Re: Montague Wind Energy Facility Change Order Request #1 (Turbine Type)

RE: Request for Determination Pursuant to OAR 345-027-0050(5) for Proposed Change to Montague Wind Power Facility – Change Request #1 (Turbine Type)

Attachment 1: Staff Evaluation of Change Request No. 1 and Determination

Figure 4-1: Illustration of outer dimensions – structure

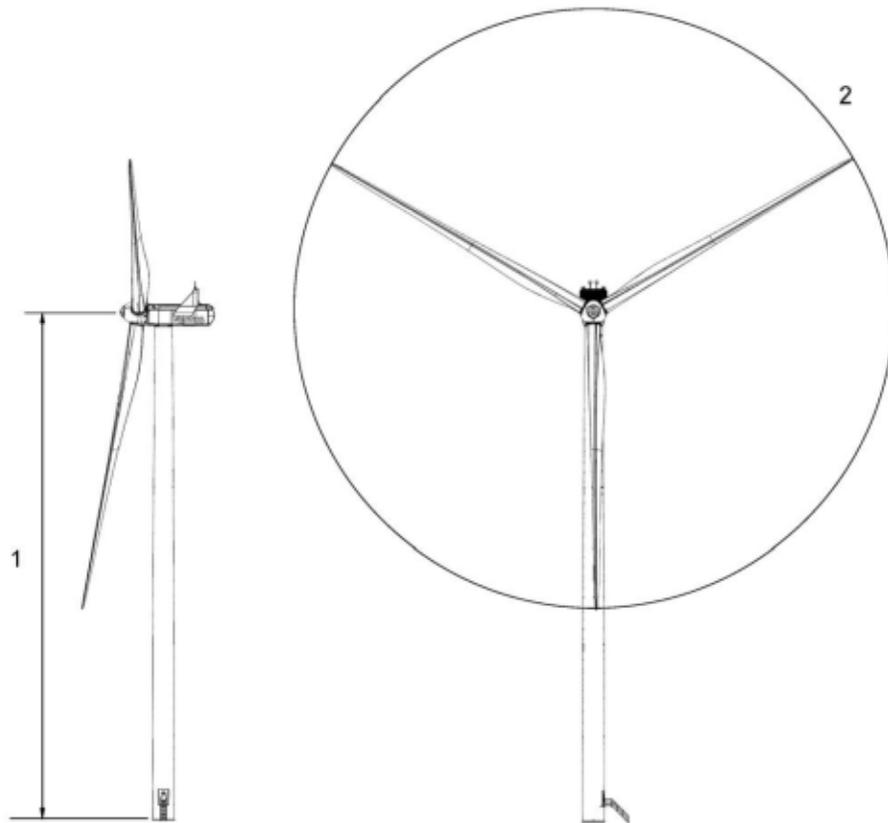
As we previously discussed, Montague Wind Power Facility, LLC ("Certificate Holder") is proceeding with construction of the Montague Wind Power Facility ("Facility") under the Second Amended Site Certificate, dated December 4, 2015 ("Site Certificate"). This letter requests that Oregon Department of Energy ("ODOE") approve a change in Facility design to allow a turbine with up to 3.65 megawatt ("MW") maximum peak generating capacity.

With the advancement in technology, turbines have a higher peak generating capacity with a smaller footprint. See Attachment 1 (Turbine Specs). Certificate Holder wishes to take advantage of a more efficient turbine type to reduce the number of turbines needed to produce the Facility's peak generating capacity of 404 MW. The new turbine type would allow Certificate Holder to significantly decrease the number of turbines, potentially by more than half.

Selecting a turbine of the similar size and scale of the previously-approved turbines ensures that even with the change in peak generating capacity, the Facility will still substantially comply with the existing Site Certificate requirements. Visual impacts would be the same as previously analyzed given no change to turbine hub or maximum blade tip heights. Permanent and temporary impacts would be less, with the Facility potentially being constructed with half the number of previously-approved turbines. The noise levels are anticipated to be similar to the previously-approved turbines and Certificate Holder will comply with Condition 107 to ensure that the Facility, with the selected turbines, complies with the DEQ noise rules. Under Condition 32, Certificate Holder will update retirement calculations and provide a bond or letter of credit based on the final design, which ultimately will be considerably less than \$21.511 million given the reduction in the number of turbines. Overall, allowing up to a 3.65 MW turbine type improves the efficiency of the Facility and minimizes impacts.

The selected turbine type would meet all requirements of Condition 27 with the exception of Condition 27(b). It is important to note that Condition 27(e) was added in the first amendment to the Site Certificate. It specifies when a change in turbine type would trigger an amendment: an increase in turbine size or total generating capacity triggers an amendment request but the condition language does not require an amendment for an increase in a turbine's peak generating capacity. This condition language is more recent than subpart (b) and provides greater specificity for determining when an amendment is required. It modifies subpart(b) and offers an avenue for ODOE to approve the use of new technology as long as the turbine type is the same scale and size as what was previously approved. Therefore, notwithstanding the reference to 3.0 MW peak generating capacity in the Site Certificate, use of a turbine with up to a 3.65 MW peak generating capacity is allowable.

The Department agrees with the certificate holder's evaluation under OAR 345-027-0050 and finds that the proposed request for flexibility in final turbine model selection does not require a site certificate amendment. The Department agrees that the requested flexibility, and increase in individual turbine generating capacity from 3.0 to 3.6 MW, does not cause a significant adverse impact to a resource protected by EFSC standards, and does not substantially impair the certificate holder's ability to comply with site certificate conditions. Compliance with applicable EFSC Standards, state and local laws, rules, and ordinances will not be affected by the requested change. In accordance with the requirements of OAR 345-027-0050(4), the certificate holder shall include a description of the modifications and the Department's determination in the next annual report and semiannual construction report. ODOE will also document the change in an order associated with the next site certificate amendment.
